# Response to Submissions and Amendment Report

*164-172 and 174-194 William  
Street, Woolloomooloo (SSD-  
80211463)*

Director	Sophy Purton
Consultant	Jasmine Foster & Ella Grimson
Project Code	P0036191
Report Number	Response to Submissions and Amendment Report Final – 22 May 2026

Figure 3 Draft Plan of Subdivision

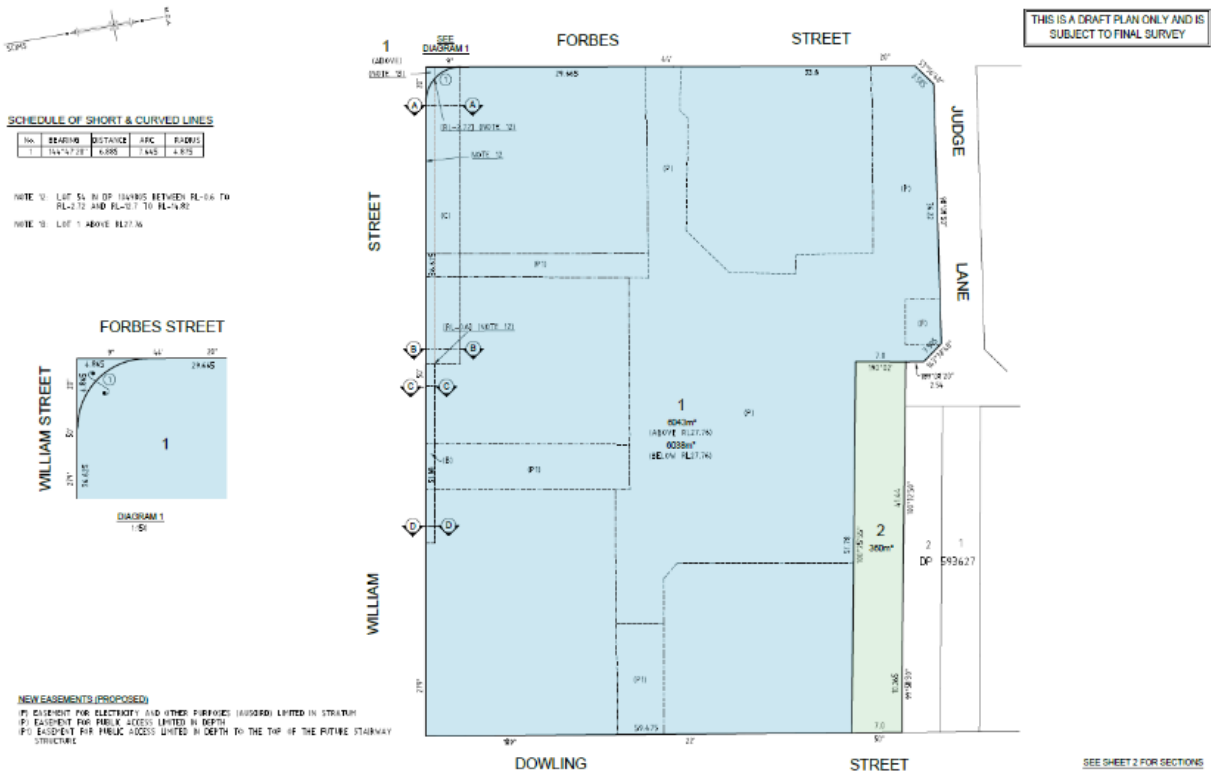
The application has been amended to include the proposed amalgamation of lots and subdivision of the land in accordance with the Draft Plan of Subdivision in **Figure 2** below (also included at **Appendix N**).

- The proposed development site – 6043sqm (1)
- The dedicated VPA land – 360sqm (2)

The location of easements relating to publicly accessible open space and public access have also been identified on this plan. The four buildings will be located on one Torrens title. It is also noted that the strata subdivision of the site will occur prior to the occupation of the site. As requested by the CoS and queried by DPHI, subdivision is proposed under this application to allow the VPA land to be dedicated to the CoS and to allow the CoS to be the Principal Certifier for the works to be carried out on this land.

Figure 4 Revised Building Massing

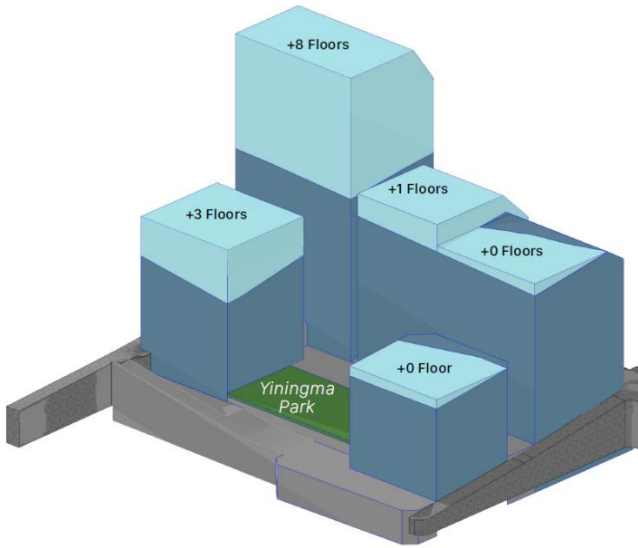
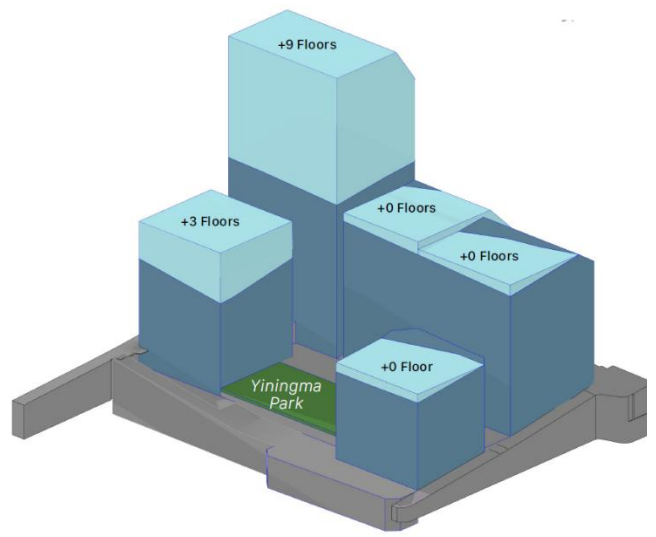
Following public exhibition, the proposed building envelope has been further refined in response to concerns regarding view impacts raised by CoS Council, the DPHI, and community members.

This redistribution of building mass represents a strategic adjustment, relocating built form to further enhance view sharing across the site.

Picture 1 Option 6 – SSDA lodgement scheme  
Source: FJC Studio

Picture 2 Option 7 – RtS revised scheme  
Source: FJC Studio

Figure 5 William Street Elevation

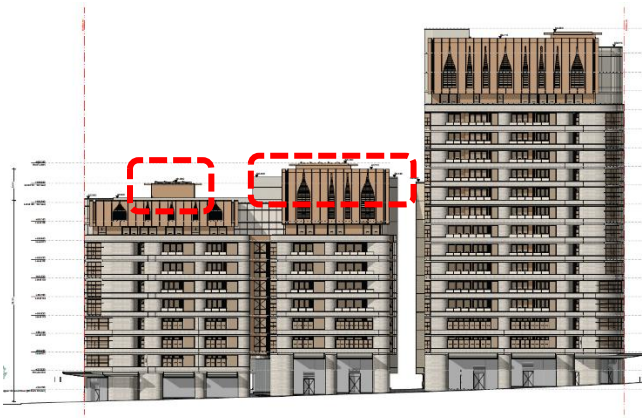
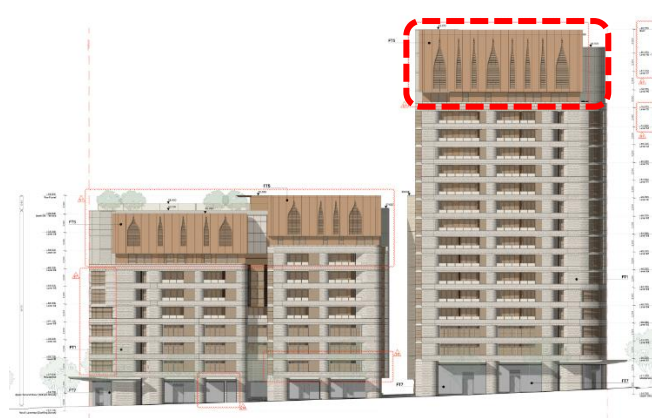
Picture 3 Lodged William Street Elevation showing areas proposed to be removed  
Source: FJC

Picture 4 RTS William Street Elevation showing new additions  
Source: FJC

Figure 8 Refined William Street Building Façade and Apartment Layouts

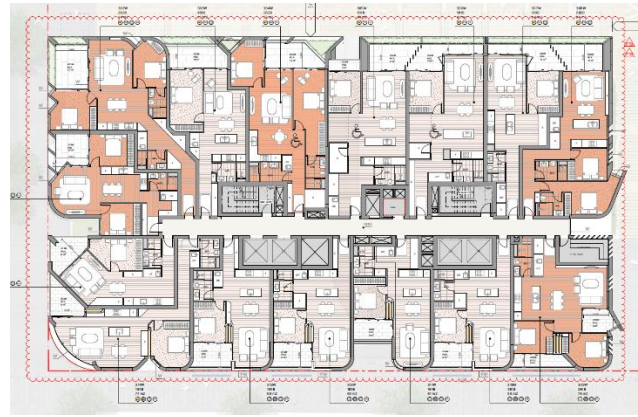
Since the lodged scheme, and in response to DIP feedback, the design of the northern façade and western facade of the William Street buildings and their internal layouts has been refined to balance solar access, privacy concerns, cross ventilation and functionality. As such, there have been minor changes to the articulation of the façades to simplify them and reduce solid elements such as privacy blades as the privacy mitigation measures have been addressed on the northern buildings and therefore are not required on the William Street building. Similarly, in response to DIP feedback, the apartment layouts have been simplified to increase efficiency and usability of space (see Figure 8 below).

Picture 9 Lodged Façade and Apartment Layout (Level 03)  
Source: FJC Studio

Picture 10 Rts Proposed Façade and Apartment Layout (Level 03)  
Source: FJC Studio

Figure 9 Refined Dowling Street Northern Balconies and Apartments

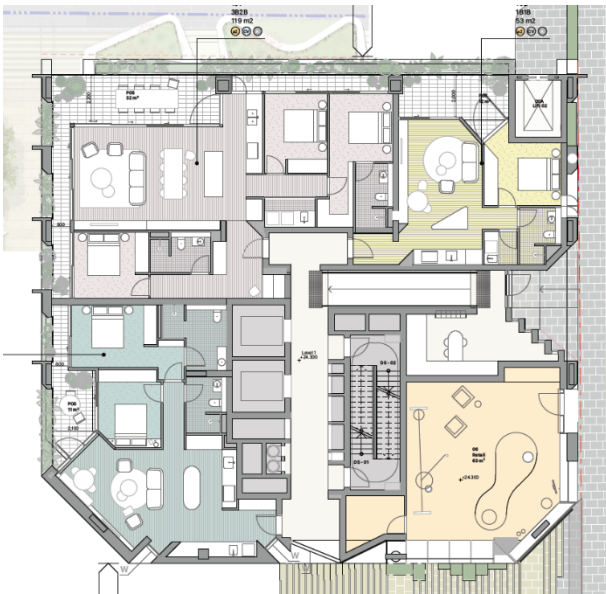
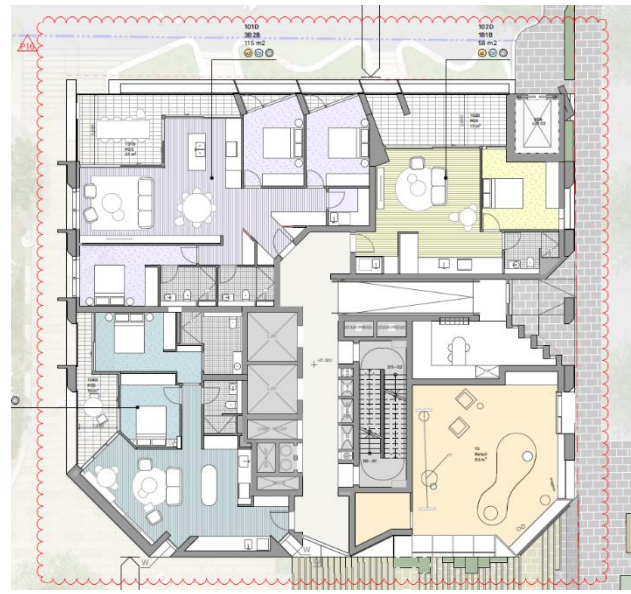
Similarly, in response to DIP feedback, the north-facing balconies of the Dowling Street building have been refined to provide a regular rectangular form whilst responding to privacy concerns, improving usability and delivering improved internal amenity outcomes. Internal layouts have also been adjusted to reflect this feedback.

Picture 11 Lodged Dowling Street Balconies and Apartment Layouts (Upper Ground Floor)  
Source: Tribe Studio

Picture 12 Rts Proposed Dowling Street Balconies and Apartment Layouts (Upper Ground Floor)  
Source: Tribe Studio

Figure 10 Updated Penthouse Section

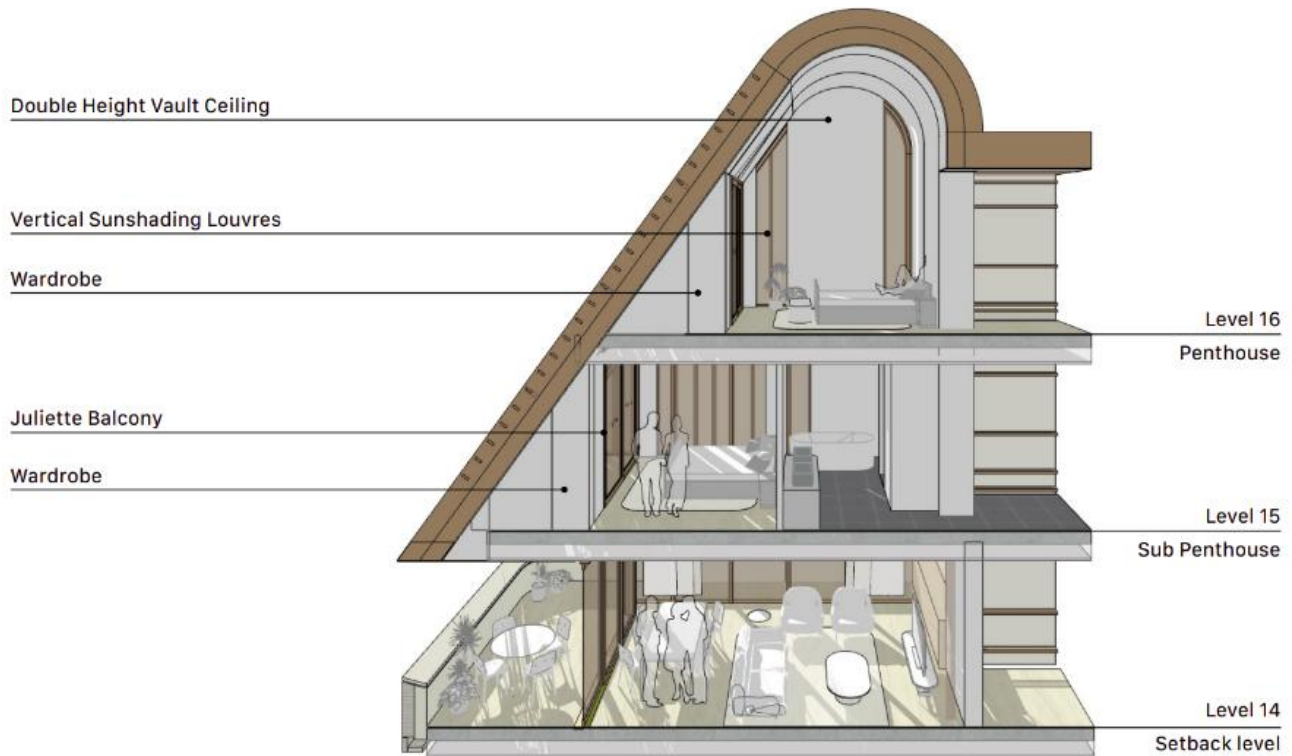
In response to concerns raised by the DIP in relation to the thermal comfort of the south-facing penthouse apartments on the William Street buildings, further design refinements have been made.

Juliet balconies have been introduced in the bedrooms to enable ventilation along with vertical sun shading louvres (see Figure 10 below). Additionally, reduced glazing has been achieved through the introduction of solid facades with narrow deep windows at the east and west roof ends to regulate thermal comfort during summer.

Figure 11 Swept path diagram showing driveway width reduced to 6m

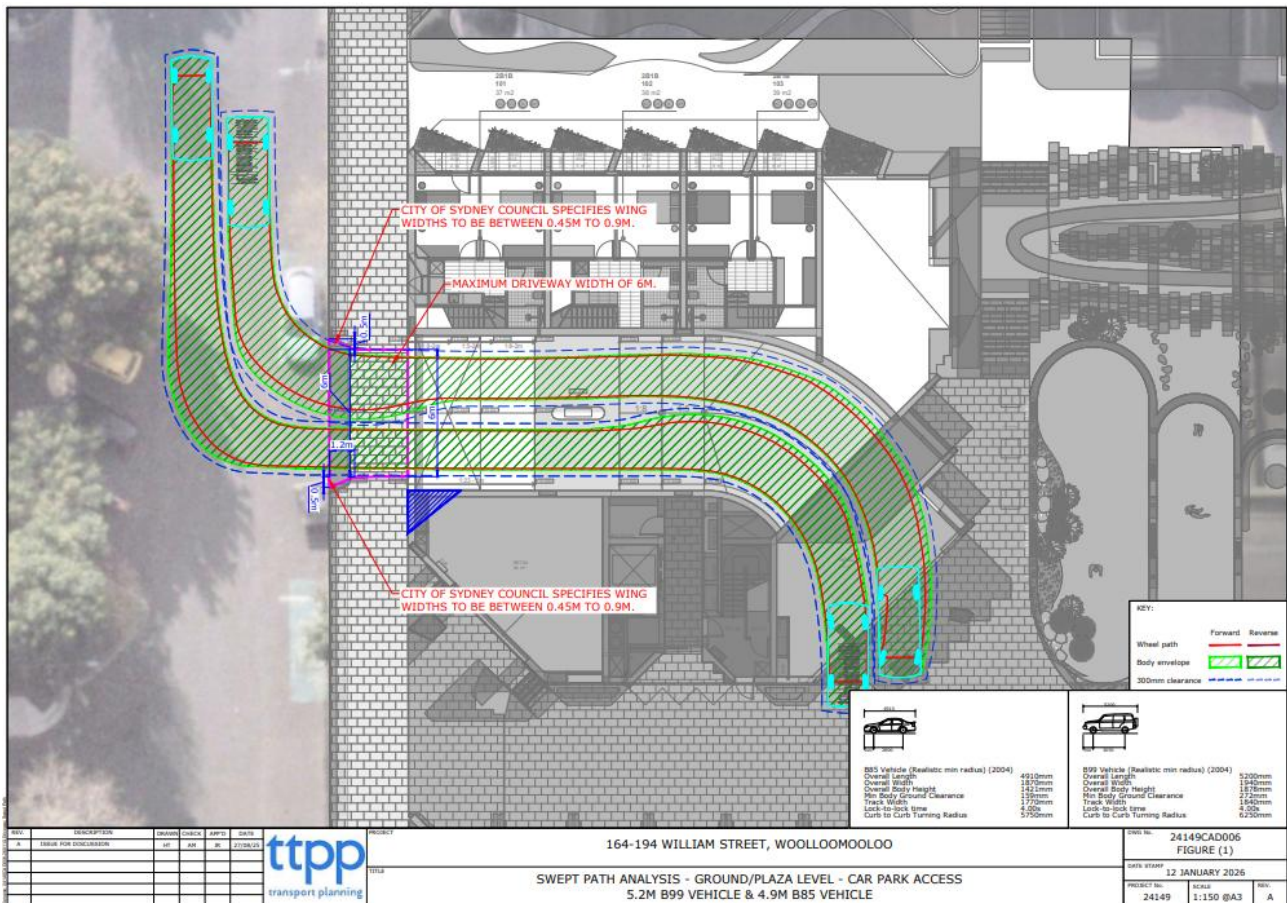
In response to concerns raised regarding driveway width, streetscape impacts and the consolidation of vehicle access on Forbes Street, the proposed vehicular access arrangements have been reviewed and refined.

Importantly, the existing site conditions accommodate up to seven (7) driveway crossovers across multiple street frontages, whereas the proposed design consolidates basement access and servicing into two (2) crossovers located solely on the Forbes Street frontage. In response to the matters raised during exhibition, the two driveways proposed along Forbes Street have been reduced to a maximum width of 6 metres, plus splay, in accordance with the CoS Technical Specifications Part C. These changes have been supported by TTPP Transport Planning, including the preparation of revised swept path assessments demonstrating that the 6 metre driveway design can function appropriately.

Figure 12 Rooftop Communal Open Space

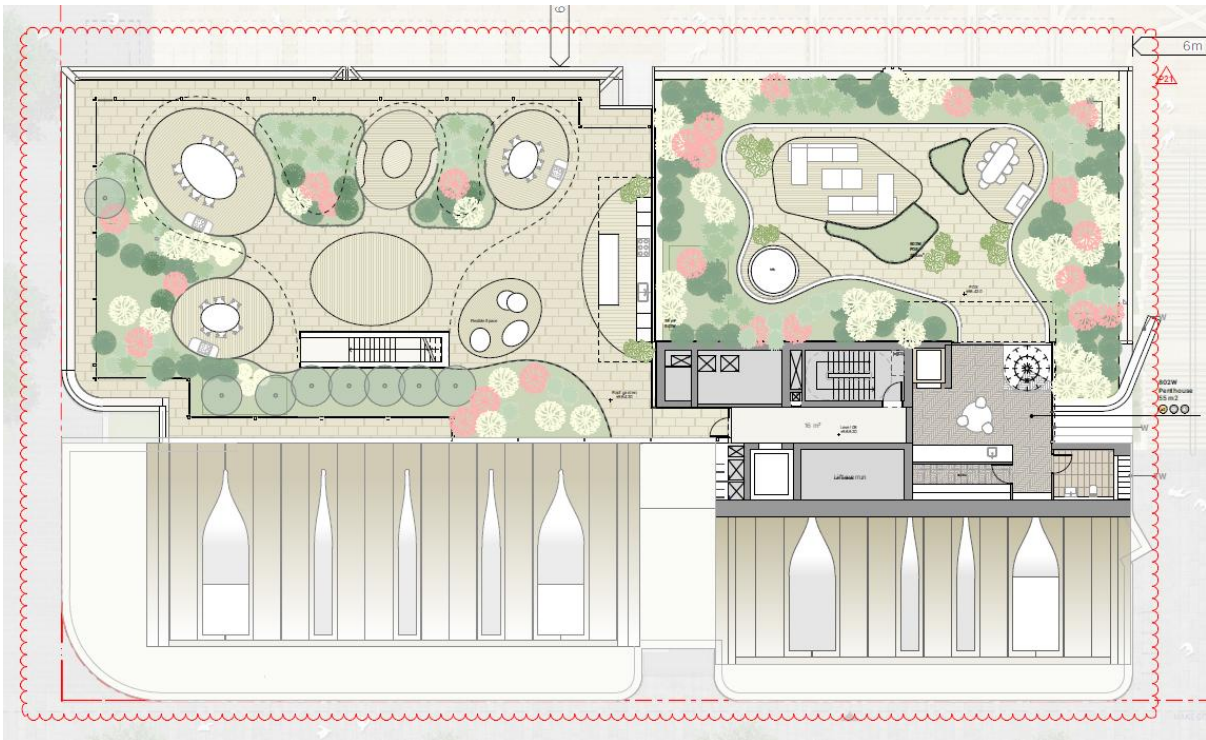
Additional wind mitigation measures have been incorporated into the proposed design to ensure that areas affected by wind achieve the relevant pedestrian comfort criteria. Rooftop areas on the William Street buildings are subject to stronger wind conditions due to their elevation and exposure. In response, high perimeter glazed balustrades with a minimum height of 1.8 metres have been incorporated, in accordance with recommendations in the Updated Pedestrian Wind Assessment (**Appendix K**). Roof articulation to the south, together with plant and lift overruns, will provide additional shielding from prevailing wind directions. These measures are anticipated to improve rooftop wind conditions, achieving Pedestrian Sitting comfort in the more sheltered southern areas and Pedestrian Walking conditions toward the more exposed northern edges.

Figure 18 Amended William St Elevation

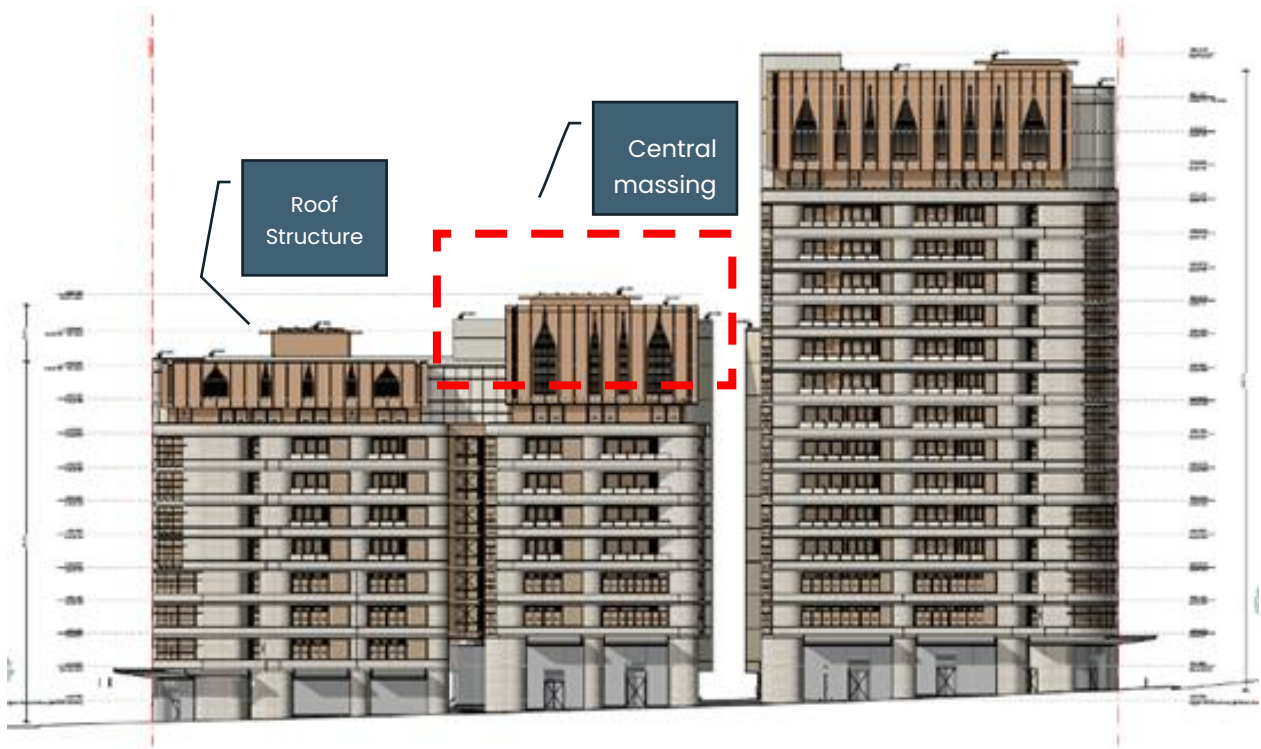
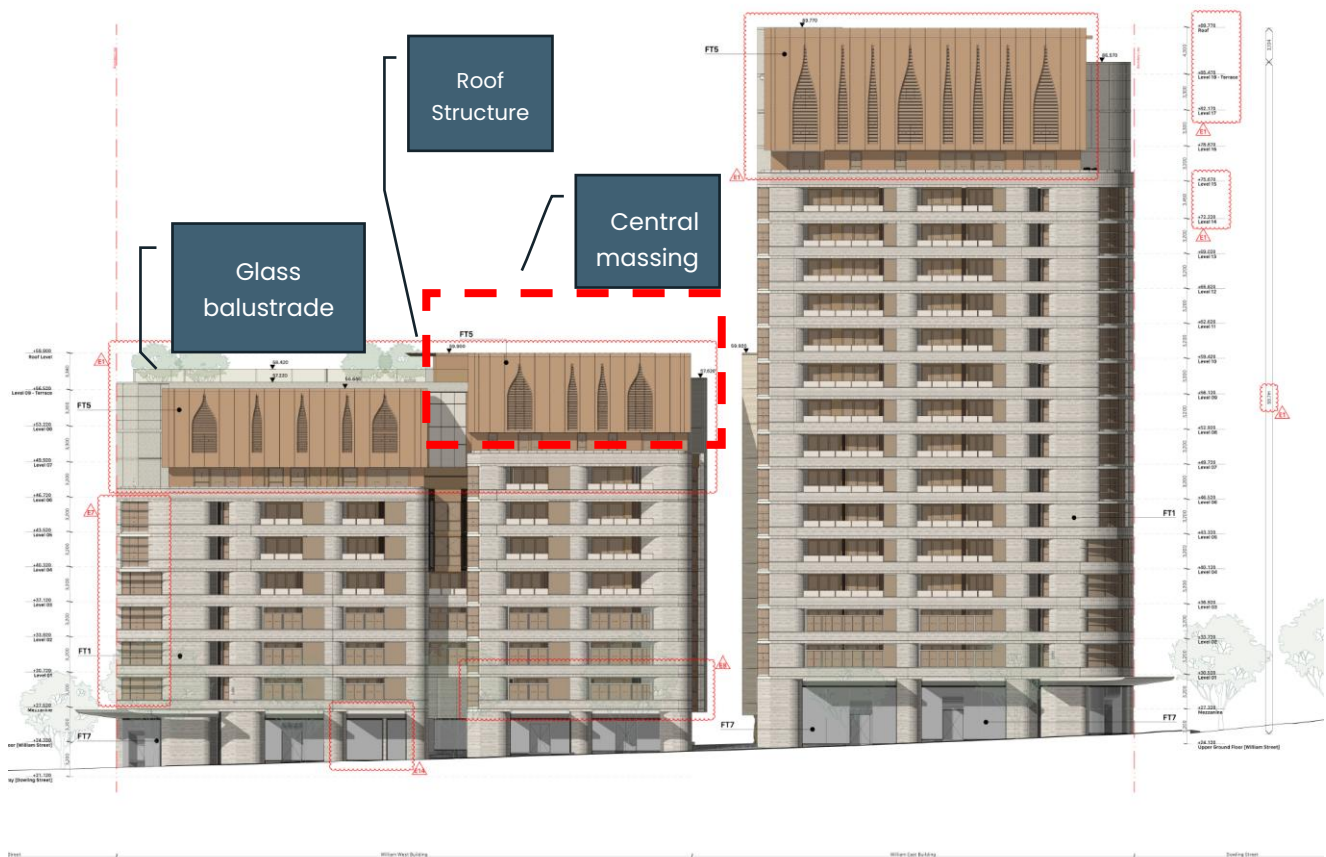
The elevation also demonstrates that, as part of this amendment, the roof top features within the south western portion of the building have since been removed and replaced with a glass balustrade which provides for unobstructed views, and extends to a maximum of 1.8m above the apex of the roof.

The roof top features that were originally visible and sat 1m above the central massing have also been removed and this central massing has been reduced in height from RL63.1 to RL59.9.

Figure 23 Central Plaza wind Mitigation Strategy

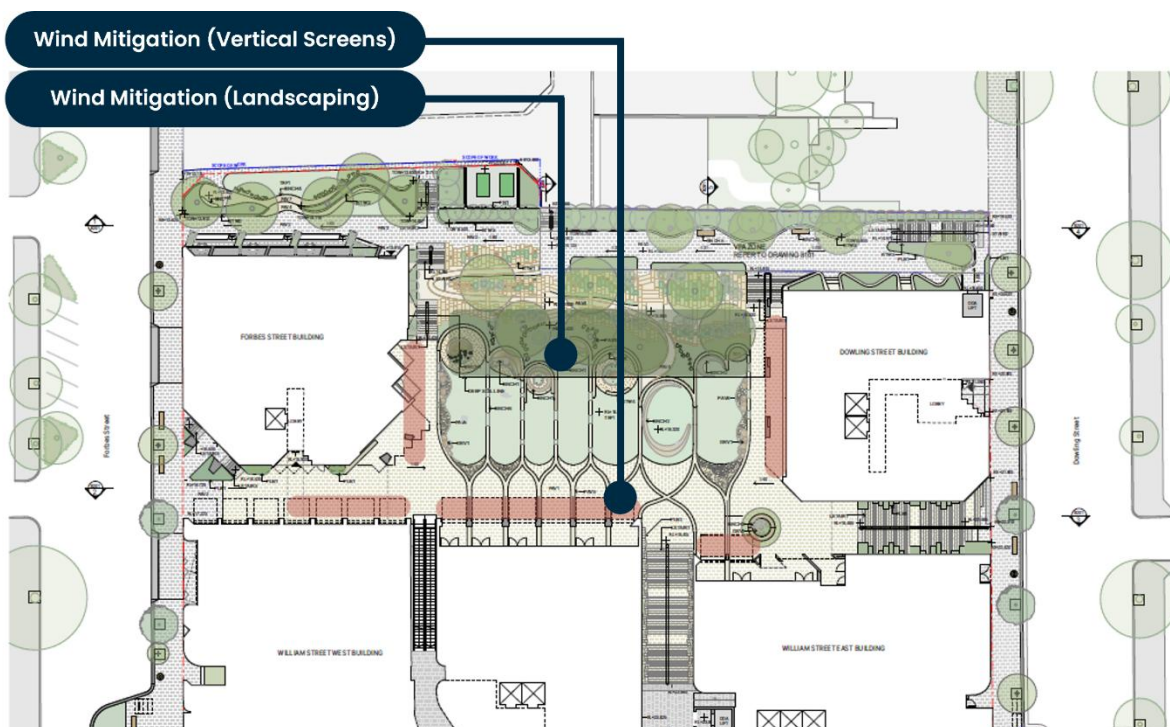
The increase in balustrade heights to 1.8 metres is expected to materially improve conditions in areas intended for resident use. Overall, the rooftop is anticipated to support a mix of uses, with sheltered areas suitable for sitting and more exposed edges appropriate for movement, which is consistent with expectations for rooftop open space in this context and considered suitable from a wind perspective.

Within the central plaza, targeted wind mitigation measures have been introduced to create localised calm areas suitable for longer-term stationary activity consistent with the Pedestrian Sitting classification and the intended use of the space (refer to the updated Mitigation Measures Table at **Appendix D**). These measures include the installation of vertical screens around outdoor dining areas and the introduction of wind-mitigating landscaping in the locations identified in **Figure 14** below.
